Form 3160-3				SUBMIT IN	TRIPLICATE*			
		INITED STATES MENT OF THE IN						
	5. LEASE DESIGNATION AND SERIAL NO.							
	Joint Venture Agreement							
APPLI 1a. TYPE OF WORK	CATION FOR	R PERMIT TO D	RILL OR DE	EPEN		6. IF INDIAN, ALLOTTEE O Jicarilla Apac	che Tribe	
DRILL	✓	DEEPEN 🗌				7. UNIT AGREEMENT NAM Joint Venture

1. Type of Well Oil Well Gas Well Other 2. Name of Operator Jicarilla Apache Energy Corpora 3. Address and Telephone No. P.O. Box 710, Dulce, New Mexico	tion 87528 Mr.Jesse Evans (505)759-3224	8. Well Name and No. Jicarilla Apache JV5 #8 9. API Well No. 30-039-2709/ 10. Field and Pool, or Exploratory Area

Drilling Program Jicarilla Apache Energy Corporation APACHE JV 5-8

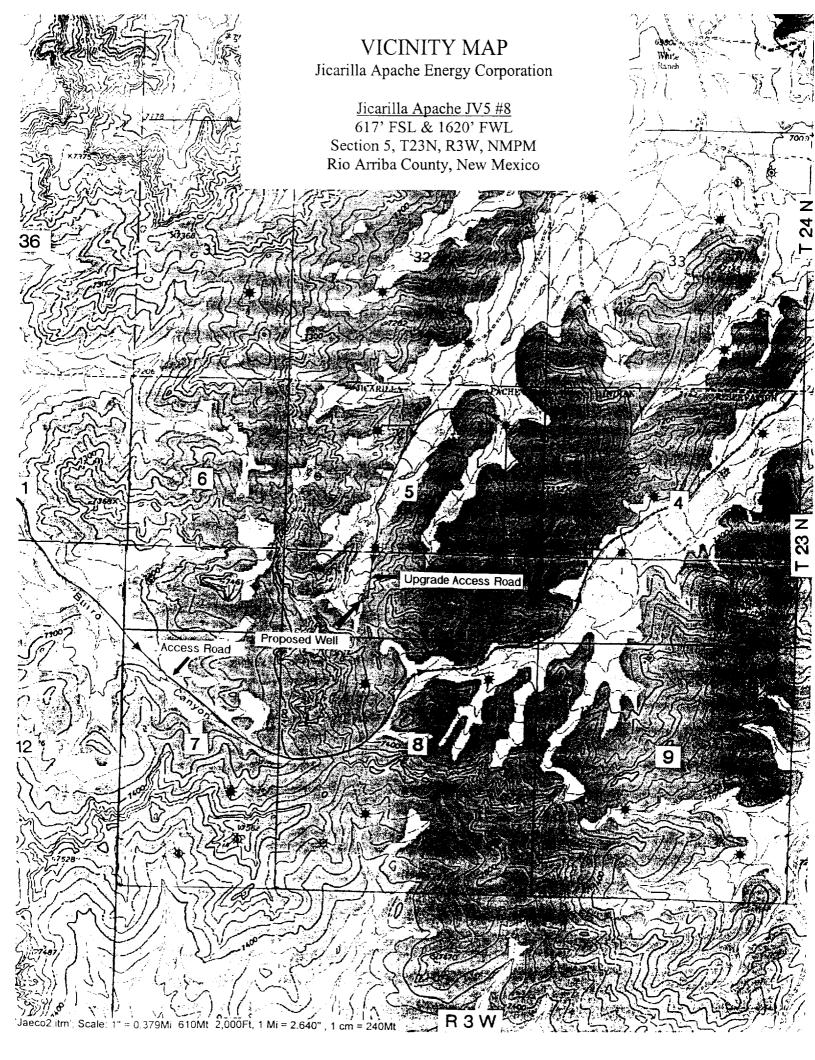
320.00 3 2 1 16D ac. 160 ac. Charles Neeley 320.00 Agent Title 07/10/02 Date Location moved 30' East with chain & compass to 1650' FWL 18SURVEYOR CERTIFICATION JV5 #4 1840'FSL & 1840'FWL I hereby certify that the well location shown on this APt: 30-039-22014 plat was plotted from field notes of actual surveys made by me or raider my supervision, and that the 00 same is true and correct to the best of my belief. 2002 May 17, <u>#</u>0 160 ac. 160 ac. Date of Surve Proposed Location 1650' 61 ار 52|80.00 11222

4. Location of Well (Footage, Sec., T., R., M., or Survey Des 617' FSL & 1650 FWL, Sec 5, T23	cription	W. Lindrith Gallup-Dakota 11. County or Parish, State Rio Arriba, New Mexico	
TYPE OF SUBMISSION	TYPE OF ACTION		
The proposed location has been Section 5, T23N, R3W, NMPM. The	Abandonment Recompletion Plugging Back Casing Repair Altering Casing Other Move location Inent details, and give pertnennt dates, including estimated date of starting any of zones pertinent to this work.) moved 30' East by chain and compass is location is now orthodox, under Neation plat and cut and fill diagram	to 617' FSL & 1650' FWL, MOCD rules.
